Access Compliance Report

Public Rights-of-Way

(Curb Ramps)

Intersection ID: 10025537	Main Street: E_STONEWALL_ST	Cross Street: N/A	Location: NE
ADA ID: F474082F7122	Ramp Type: Directional1	Initial Pass/Fail: Pass	Overall Compliance: No
			Severity Score: 2.5

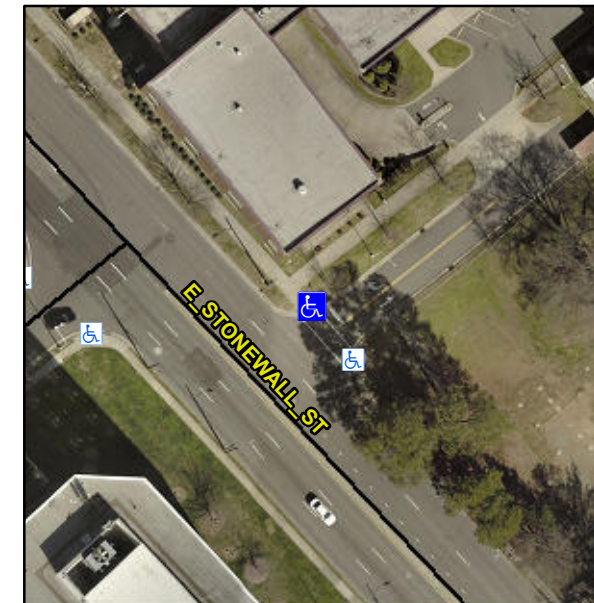
R304.2.2, R304.5.2, R304.5.3

**Remove & Replace Entire Ramp.
Remove & Replace Gutter.**
